Subject: 1969 Corvette Steering Column - Control Lock Tube Housing Cover Added

Model and Year: 1969 Corvette

Source: Chevrolet Service News

Date: April 1969 - Volume 41 - Number 4

Fig. 44—Corvette Control Lock Tube Housing Cover

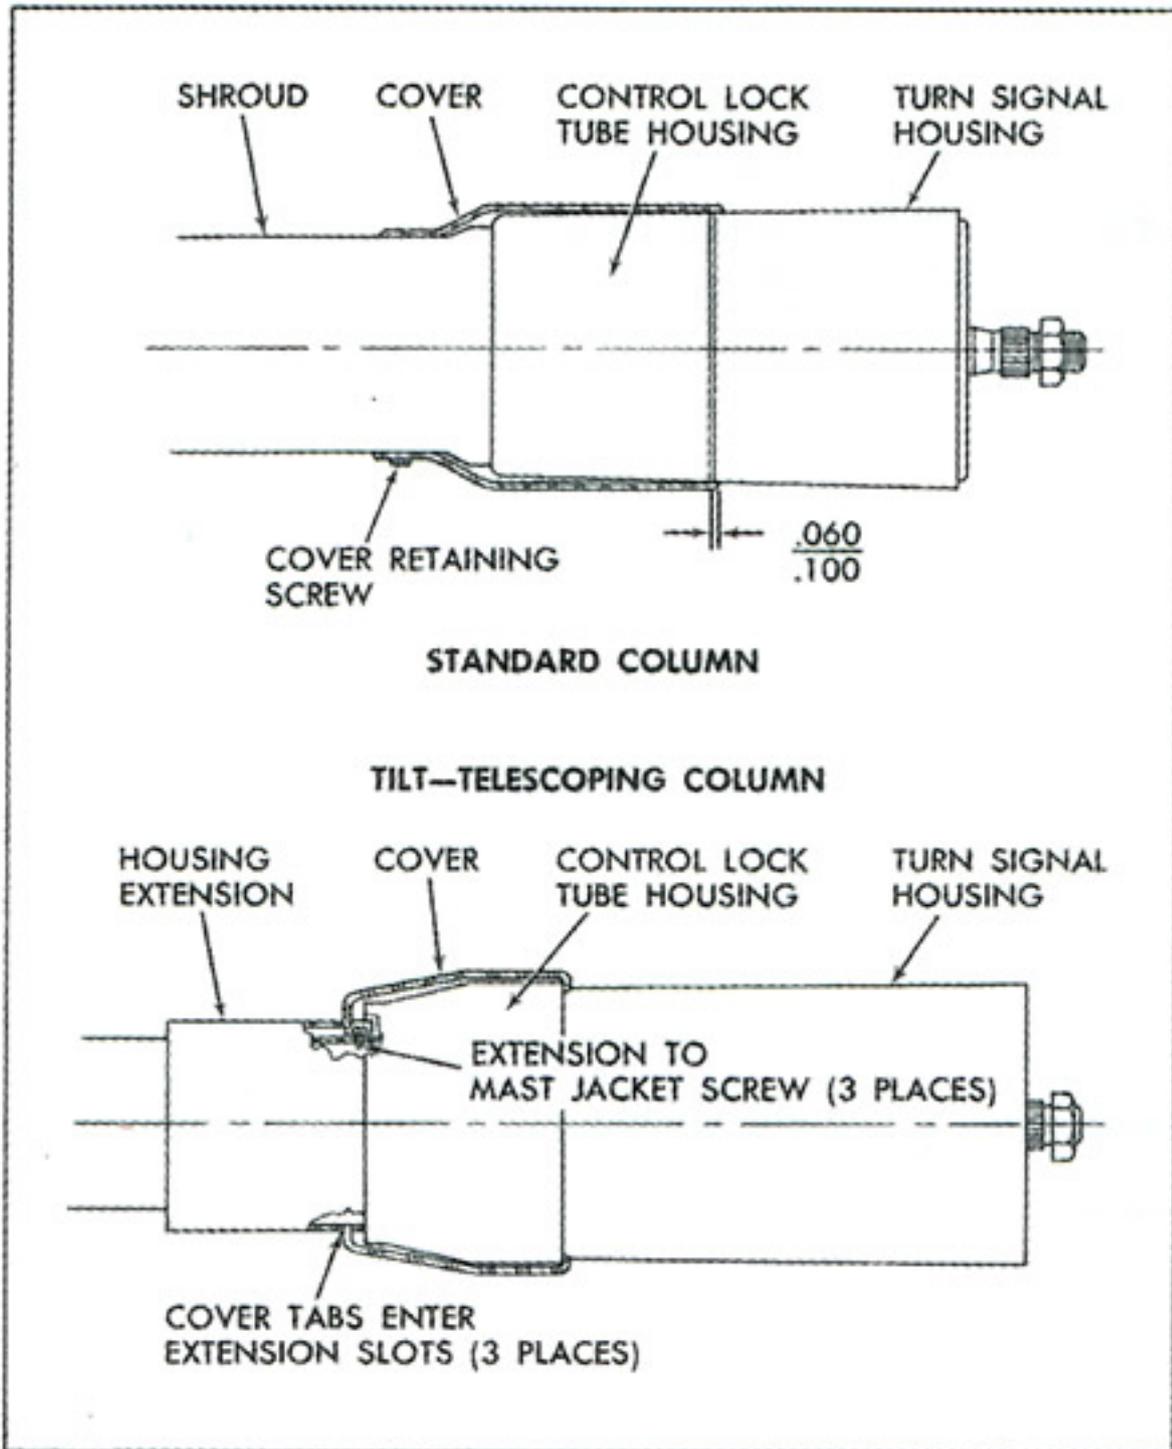
A control lock tube housing cover has recently been incorporated into the 1969 Corvette steering column, both standard and Tilt-Telescoping types, as shown in Figure 44. This cover is intended to prevent the lock tube housing from being rotated and subsequent damage to the control cable.

The following steps in the 1969 Passenger Car Chassis Service Manual should be revised:

On Page 9-14, Step 10 of the procedures for 'Disassembly - All Except Tilt and Tilt-Telescoping Columns; should appear as follows:

10. Remove the gearshift lever housing and shroud from the jacket assembly (transmission control lock tube housing and shroud on floor shift models).

Corvette - If either the shroud or housing cover are damaged, remove the retaining screw and slide the cover off the shroud.

On Page 9-17, Step 7 of the procedures for 'Assembly - All Except Tilt and Tilt-Telescoping' should appear as follows:

7. Install the shift tube lock plate and spring into the gearshift lever (or lock tube) housing and install the cover onto the shroud (Corvette). Install the housing and shroud assemblies onto the upper end of the mast jacket. Rotate the housing to be sure it is seated in the bearing.

On Page 9-21, Step 17 of the procedures for 'Disassembly - Tilt and Tilt-Telescoping Columns' should appear as follows:

17. *All Columns* - Remove the shift lever housing from the mast jacket (transmission control lock tube housing on floor shift models). Remove the shift lever spring by winding the spring up with pliers and pulling it out. on floor shift models, remove the spring plunger.

Tilt-Telescoping Columns - Pry the transmission control lock tube housing cover tabs out of the slots in the housing extension and remove the cover. Remove the three housing extension screws and remove the housing extension.

On Page 9-22, Step 2 of the procedures for 'Assembly - Tilt and Tilt-Telescoping Columns' should appear as follows:

2. *All Columns* - Install the shift lever spring into the housing by winding it up with pliers and pushing it into the housing. On floor shift models, install the plunger.

Tilt-Columns - Slide the gearshift lever housing onto the mast jacket.

Tilt-Telescoping Columns - Install the transmission control lock tube housing extension and torque the screws to **40 in. lbs** . Install the housing cover onto the extension. Install the housing onto the mast jacket assembly.
